**AGENDA
PLANNING AND ZONING COMMISSION
REGULAR MEETING
August 27, 2018**

Re: Todd Hills Addition

Description: Preliminary Plat

**PRELIMINARY PLAT
TODD HILLS ADDITION
TO HIAWATHA, IOWA**

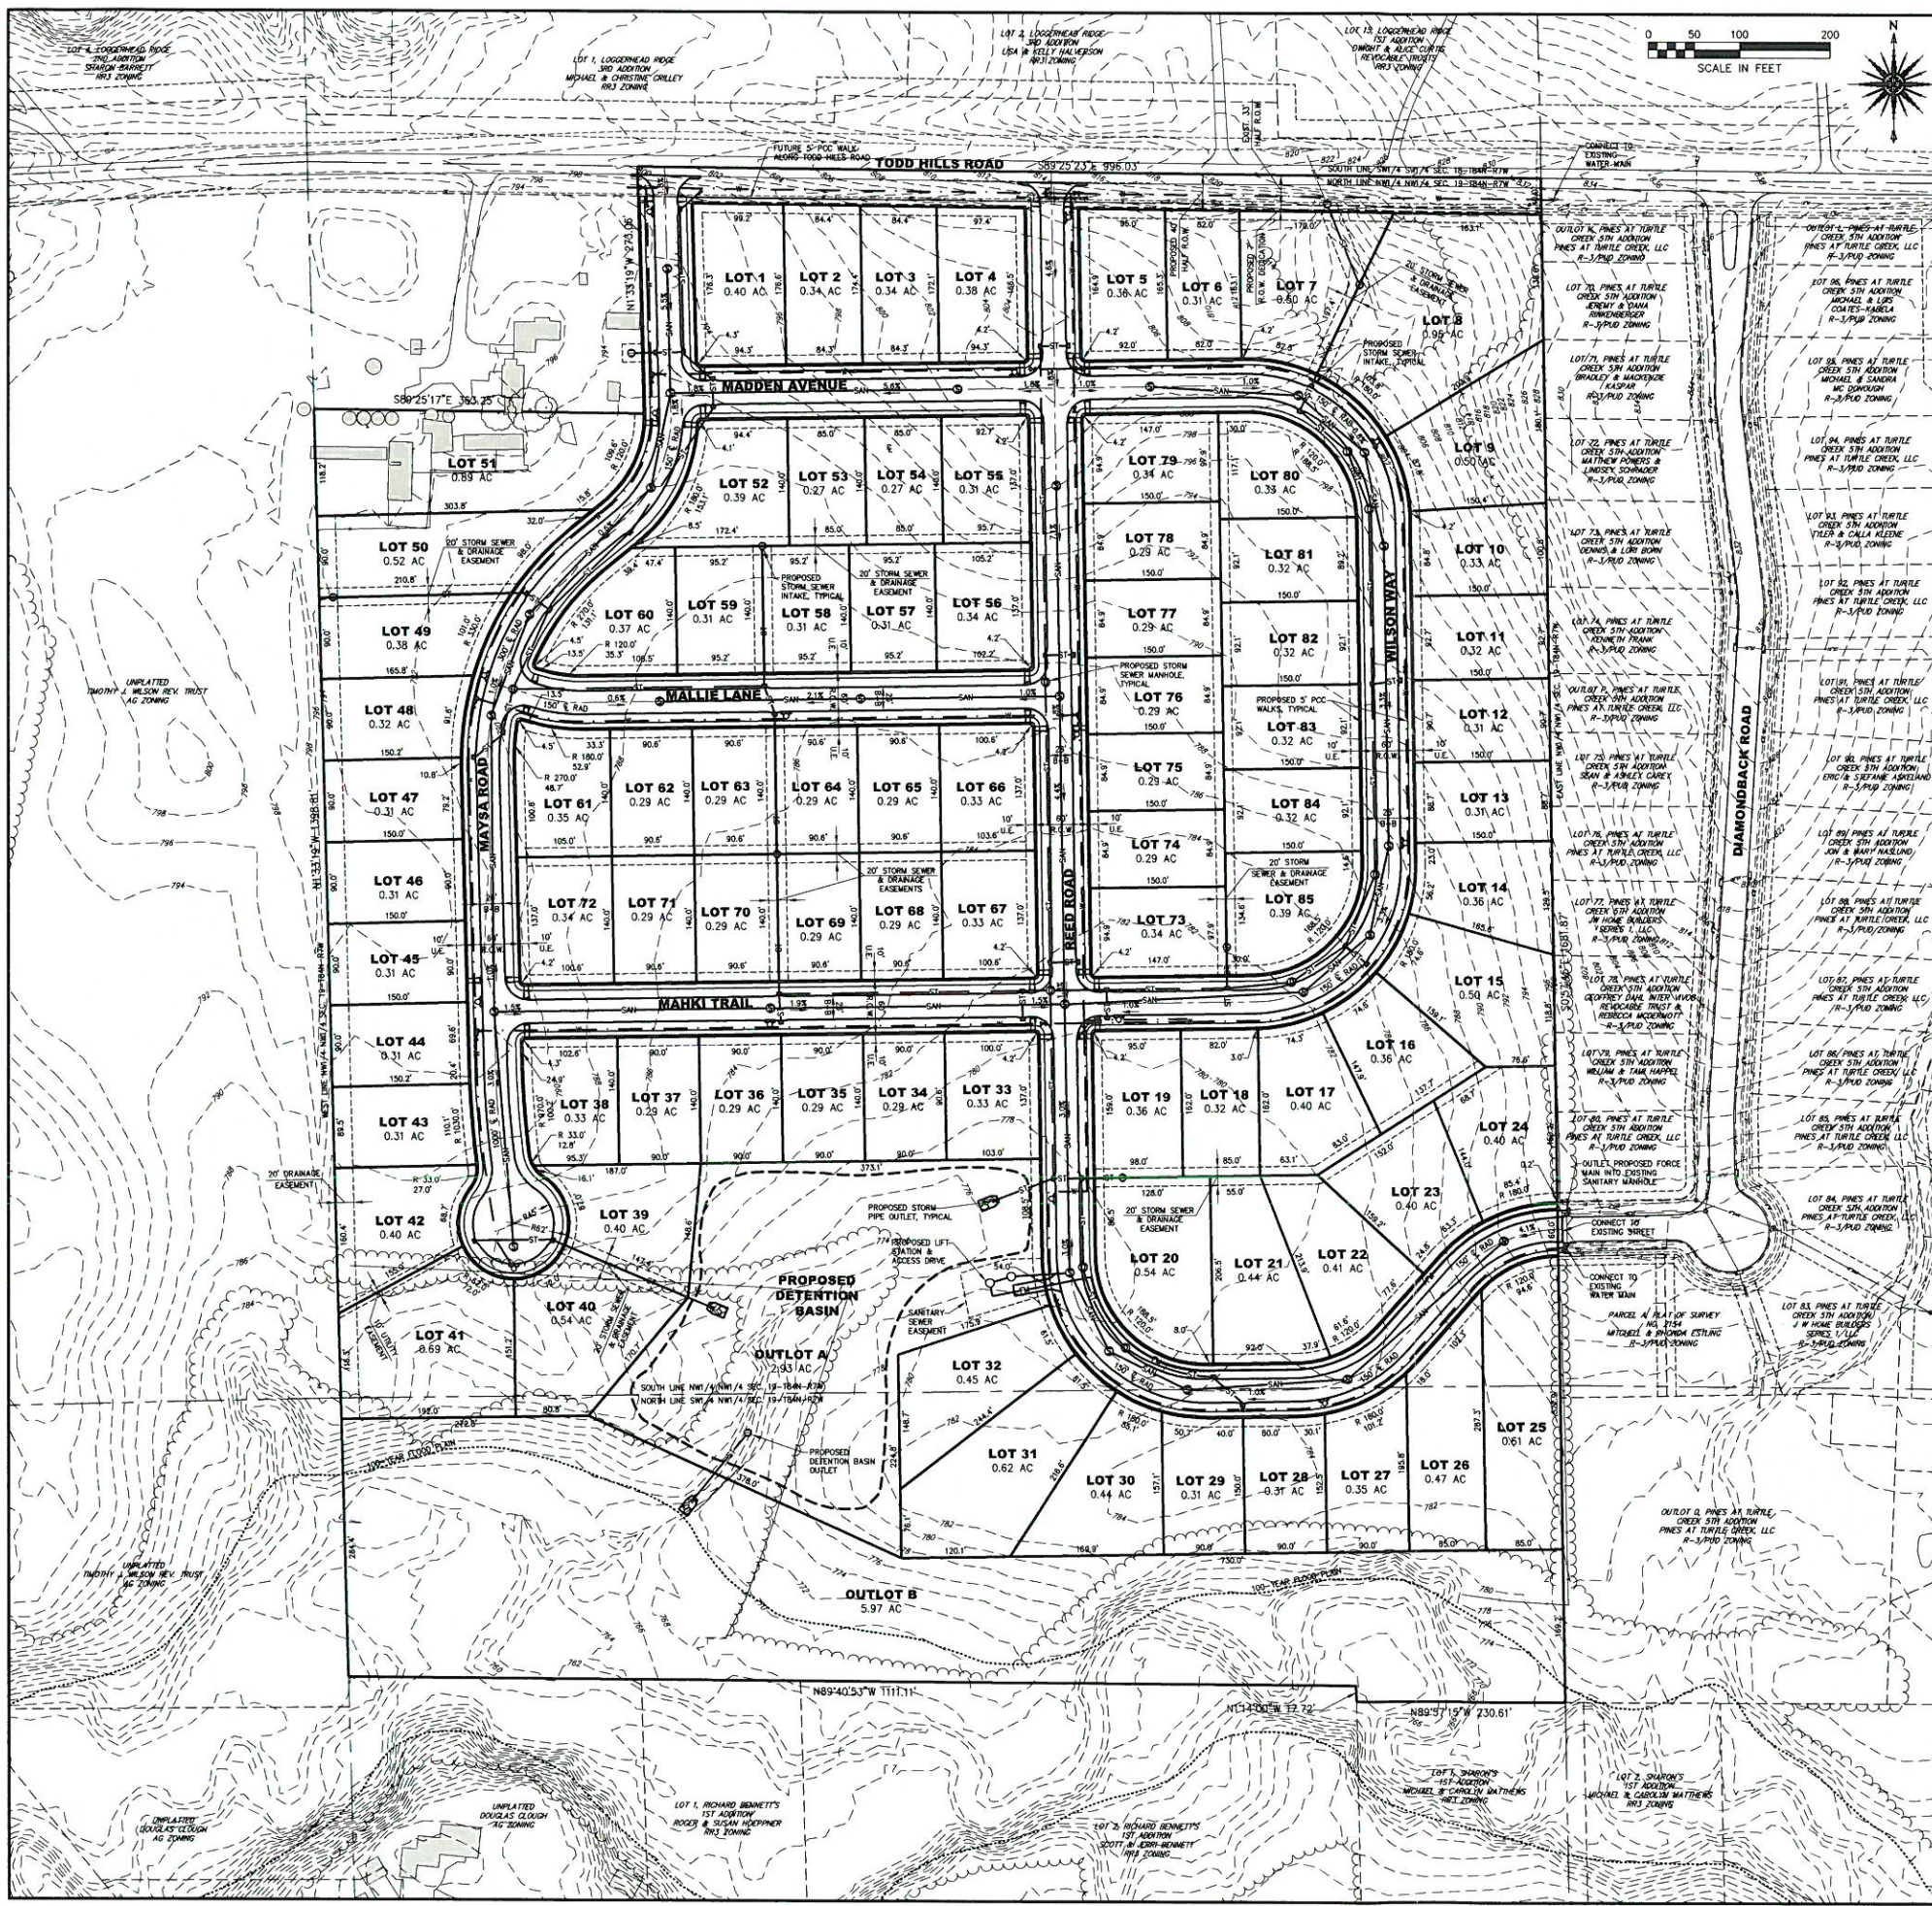
Engineering has reviewed the preliminary plat for the property located west of Edgewood Road and south of Todd Hills Road. This is approximately 50 acres of agricultural property that was recently annexed into the city. The draft proposal shown for this property is approximately 90 new residential lots of about ¼ acre in size.

Currently, the sewer and water utilities are already installed adjacent to the property from the east. Water service is more than adequate and can be looped throughout the addition. The sanitary sewer is installed to the property from the Pines at Turtle Creek addition. However, because of the elevation change, a small package sewer life station will be required to serve the entire property. The policy would be for the developer to install the pump station and the City would take over the maintenance as we do with all other developments.

During the plat review process, we asked for a minimum of two public access roads to be connected to Todd Hills Road to supplement the existing access available on Reed Road. We also asked for the internal loop street system to be renamed for the ease of understanding street addresses for emergency services. Both these request were complied with.

The proposed street layout is in substantial compliance with the anticipated low density residential subdivision and will allow adequate street and utility access. This is the first step in providing the needed long range plan for this area.

Engineering recommends approval and forwarding to the City Council for consideration.

**PRELIMINARY PLAT
SHERMAN SQUARE ADDITION, HIAWATHA, LINN COUNTY, IOWA**

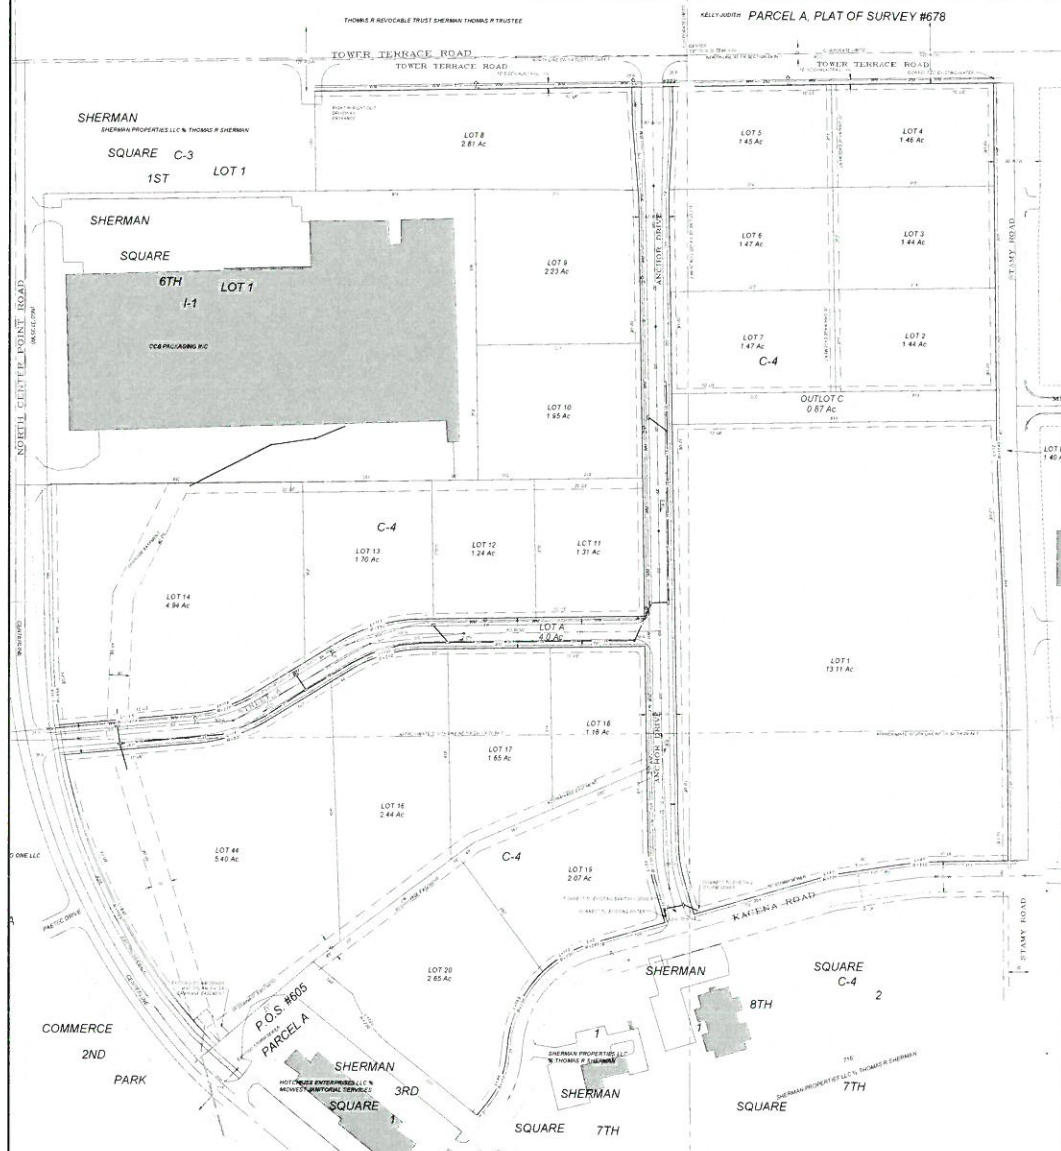
This is approximately 40 acres east of Center Point Road and south of Tower Terrace Road that had an original preliminary plat approved in the 1990's. The additions of the 1st through the 8th have been previously approved and developed. The 9th addition was just recently approved, but included a proposed street and lot layout that made the old preliminary plat not valid with the current development schedule. For that reason, we requested that the preliminary plat be revised to match the intent of how the area will be developed.

This revised preliminary plat better represents the recent opportunities for growth and how this area would most likely be developed in the future. It provides for an additional access to North Center Point Road and to Tower Terrace Road. However, the access to Tower Terrace may be a right-in and right-out sometime in the future. The proximity to the Stamy Road intersection does not meet our intended access spacing on Tower Terrace Road. As the land develops on the north side of Tower Terrace, opposing access drives might also require the installation of channelizing islands to control traffic conflicts. The developer is aware of the possibility.

The proposed roadway and lot layout is substantially in compliance with the intent of a commercial area. The plan allows for the necessary installation of adequate public utilities and access to serve the future growth.

1. The new C-4 setback requirements are noted.
2. A new standard for access spacing on Tower Terrace is now in place. The applicant is aware the Anchor Drive intersection and the driveway entrance west of Anchor Drive may become right-in-right-out with the future design of Tower Terrace Road. No additional access will be permitted on Tower Terrace Road.
3. Access to NCPR has been modified to accommodate possible future development west of NCPR.
4. Sidewalks and trails in accordance with Metro Standards on all streets abutting this development have been detailed.
5. The plat indicates the method for storm water management is per lot.

Engineering recommends approval and forwarding to the City Council for consideration. If you have any questions please let me know.
